Agenda Item: 04
 Case # SI-2023-01514
 Project # PR-2021-005685
 January 10, 2024

Supplemental Staff Report

<i>Agent</i>	Strata Design/Michelle Negrette
<i>Applicant</i>	Homewise Inc.
<i>Request</i>	Certificate of Appropriateness For Alteration
<i>Legal Description</i>	Lot 5, Block 26, Huning Highland Addition
<i>Address/Location</i>	119 High Street SE Between Gold Avenue SE and Central Avenue SE
<i>Size</i>	0.17-acres
<i>Zoning</i>	R-ML
<i>Historic Location</i>	Huning Highland Historic Protection Overlay Zone (HPO-5)

REVISED DRAWINGS

EAST ELEVATION (STREET)

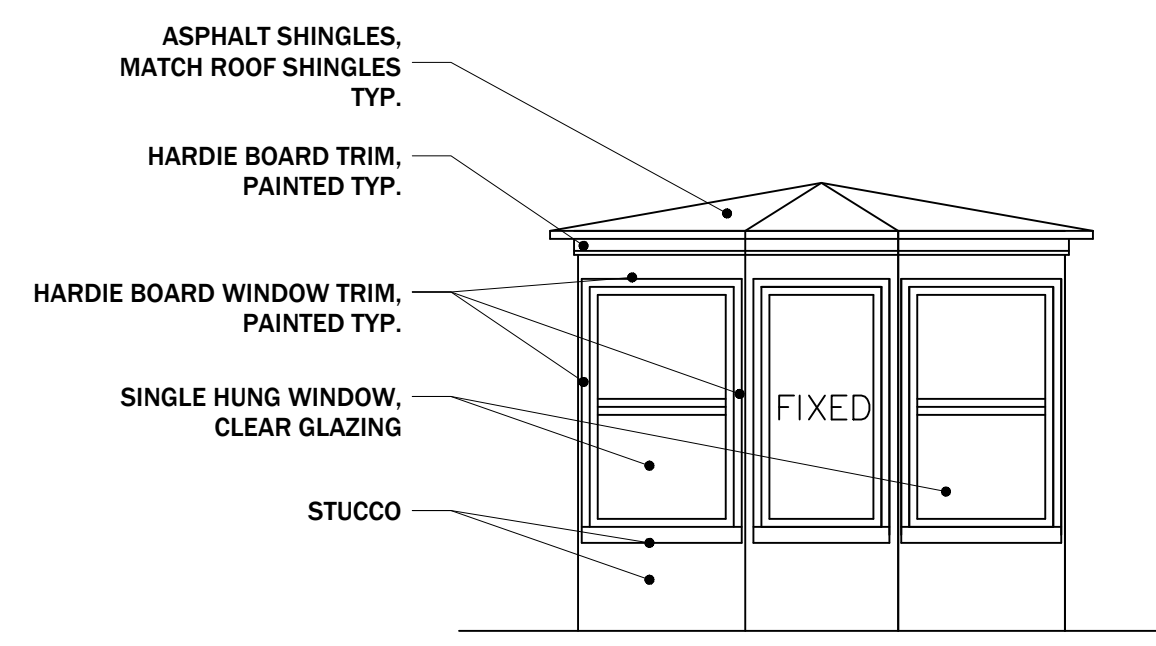
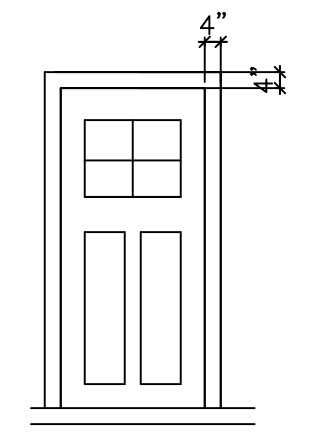
5. *Incorporate details and ornamentation found on historic buildings within the context of new construction.* Window frames are painted with extended (deeper) lower sills, dormers have shingles, porches are enclosed with 3' painted pickets and 6" square posts, fascia boards outline dormers and porches have trim detailing below roof. Window sizing and proportions are consistent with historic windows, stucco cladding is consistent with neighborhood, stone like raised foundation consistent with neighborhood.

The front elevation works well to address the scale of the adjoining building which are quite different between the north and south properties. Higher two-story elements are located on the south side of the building which is adjacent to a large brick Victorian house. The northern side of the building steps down to one-story and a cut-out for a second-story balcony, allowing it to mesh more easily with the single-story bungalow located to the north.

The front presentation of the proposed building, with 25-foot setback, enhances the district character with front porch, gabled ends and standard window spacing and proportions.

SITE PLAN 1" = 10'-0"

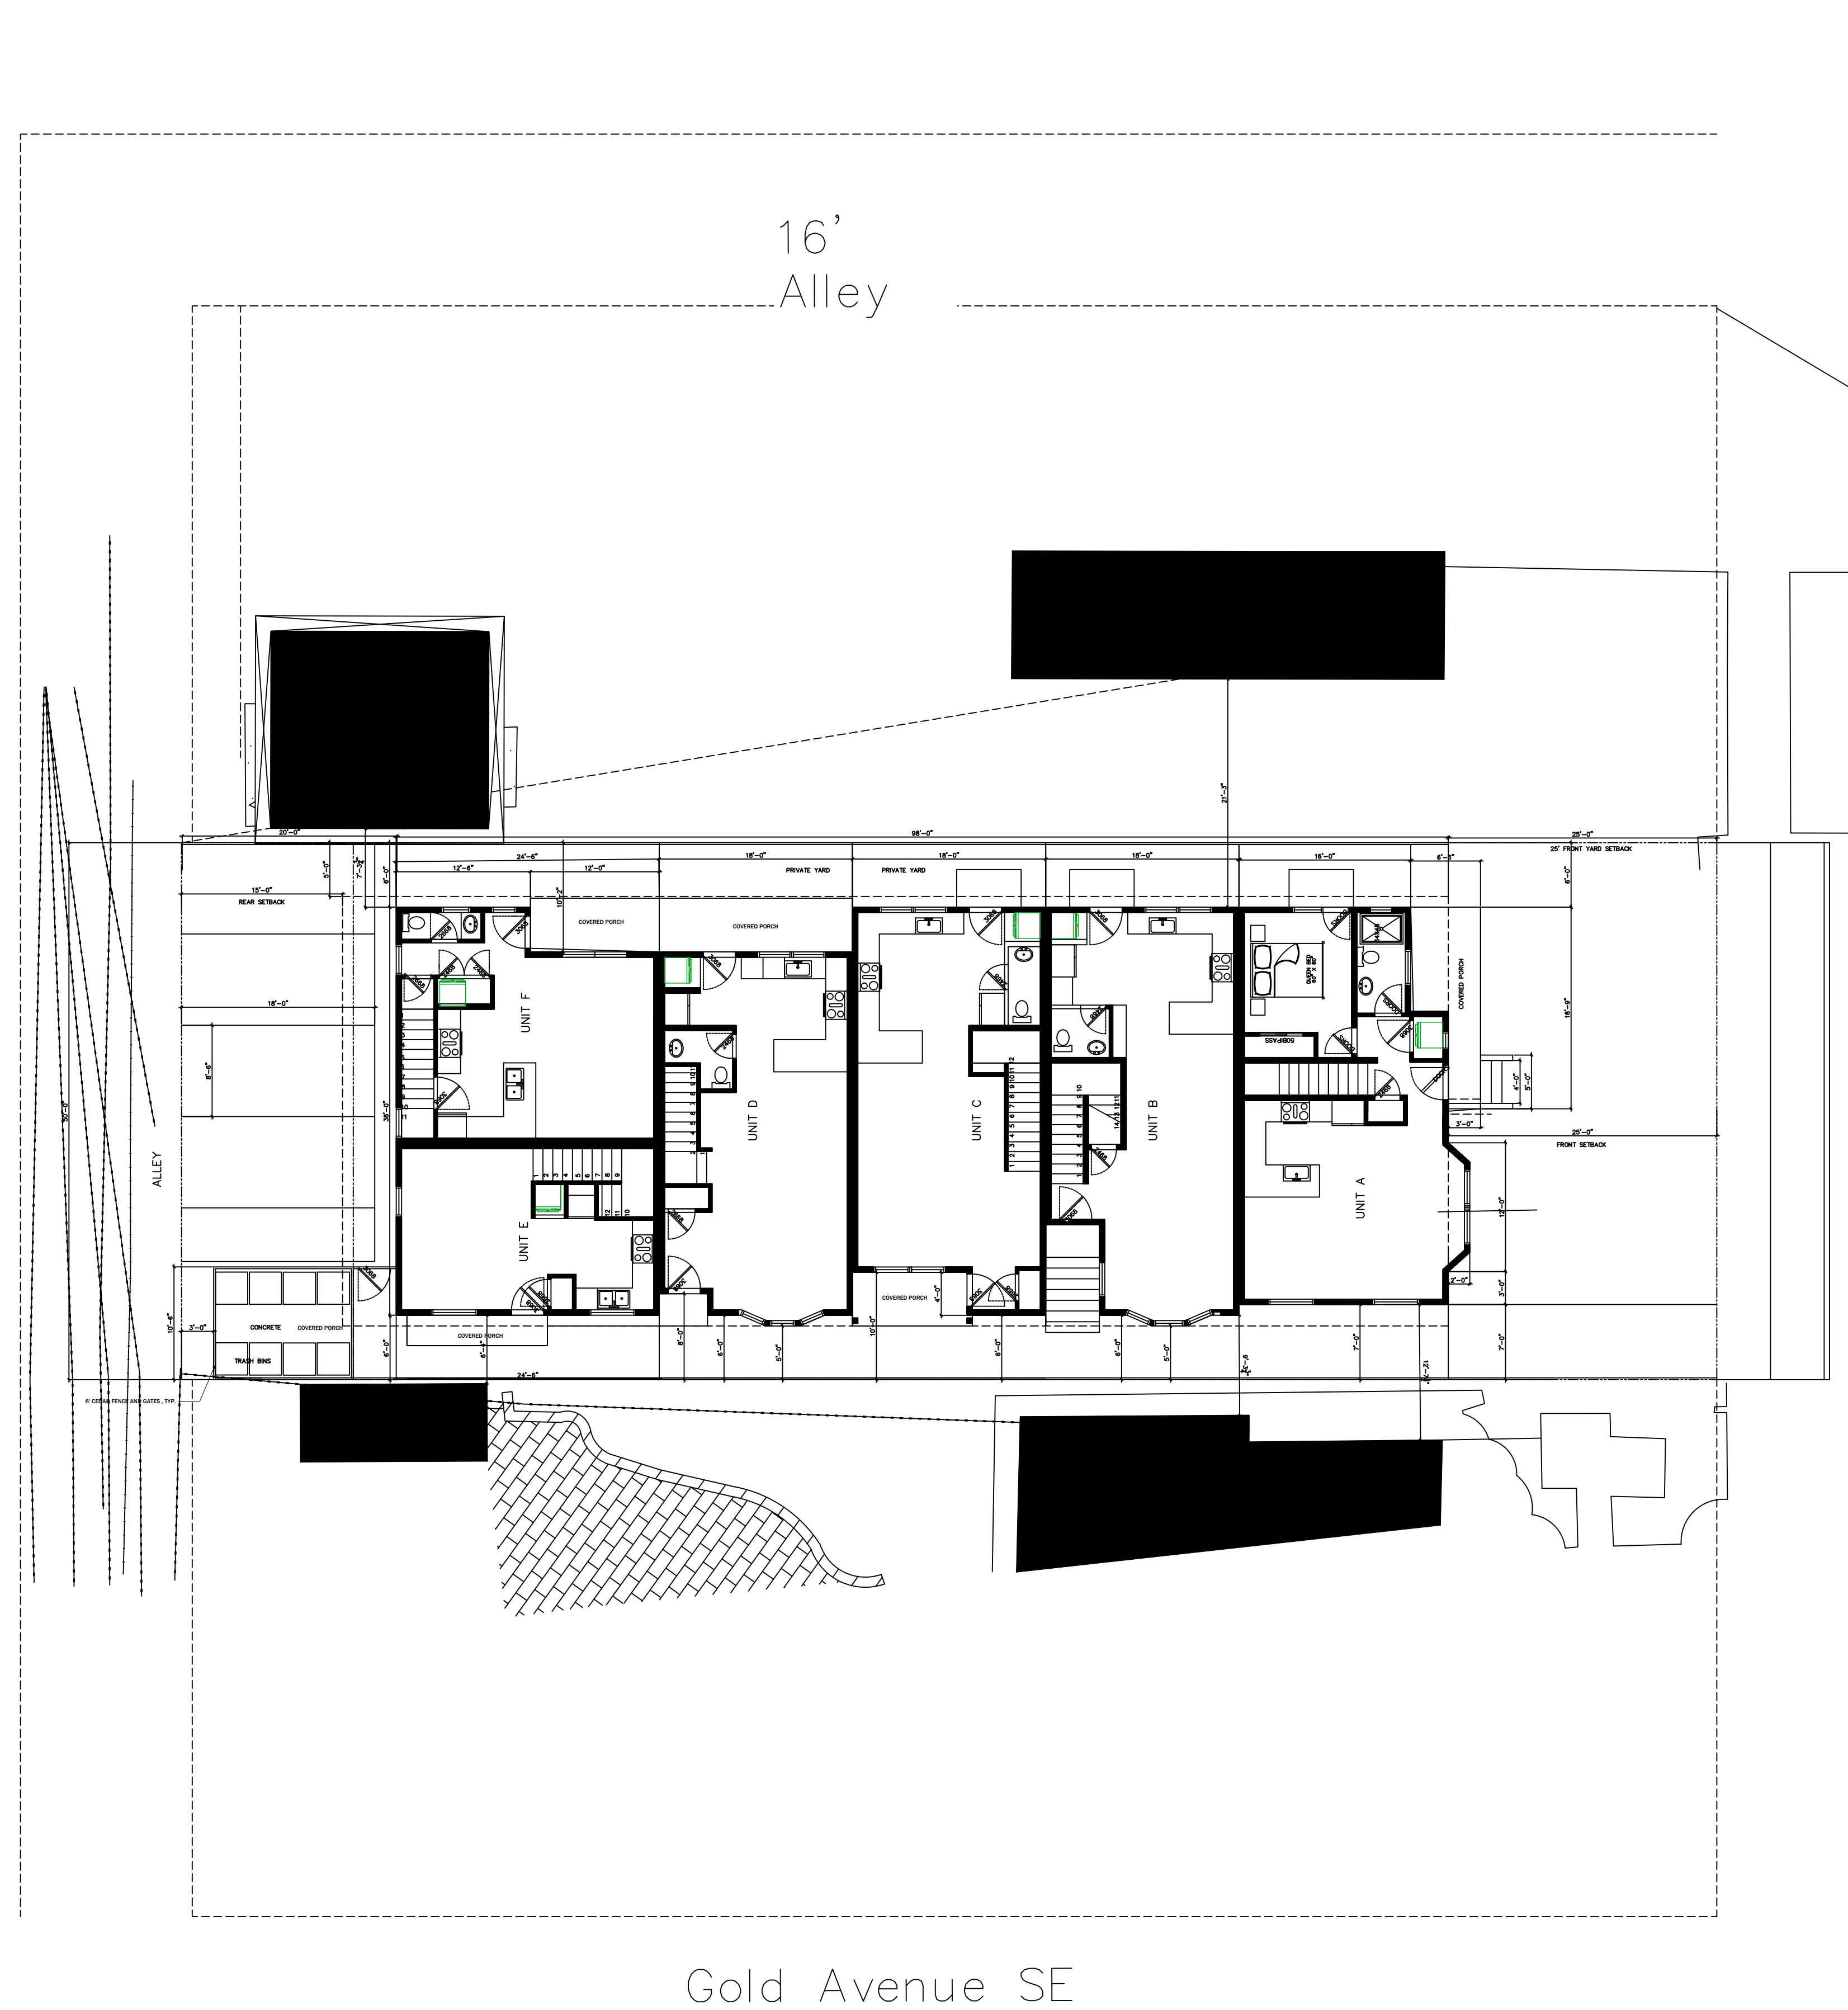
1. *Remove front yard parking space, curb cut and driveway.* Removed.
2. *Extend front setback to 25 feet from the front property line to match adjacent properties.* Front setback is at 25 feet.
3. *The space between adjacent buildings should be the same as the average space between other buildings on the block.* The building to the north is located approximately 15 feet north of the south property line. To locate the project 15 feet from south property line would make the project not feasible. The existing adjacent buildings to the north and south (and the previous building on the site destroyed by fire) were constructed prior to the existing zoning code and do not meet current side setback requirements and Solar Access

6. *Provide site plan with parking calculations (requirements/provided) and usable open space requirements.* Site plan is provided with parking requirements and provided spaces and usable open space requirements and provided per unit.

Space between buildings to the south is smaller than typically seen within Huning Highland and will result in a tight front space for those units opening on to this 5-foot space. Information was not provided for the setback of the building to the south but a greater setback for the new building would be preferred.

The proposed design has removed the front yard parking space, curb cut, and driveway. Also, the front setback is 25 feet from the front property line, which maintains the front setback on the block in the neighborhood. All on-site parking is accessed through the rear alley. Two parking spaces are available as on-street parking.

PARKING REQUIREMENTS
 TOWNHOUSE: 1 SPACE FOR UP TO TWO BEDROOMS
 6 2-BEDROOM UNITS = 6 PARKING SPACES REQUIRED
 6 PARKING SPACES PROVIDED ON SITE
 2 ON STREET PROVIDED
 4-5 ON SITE PROVIDED
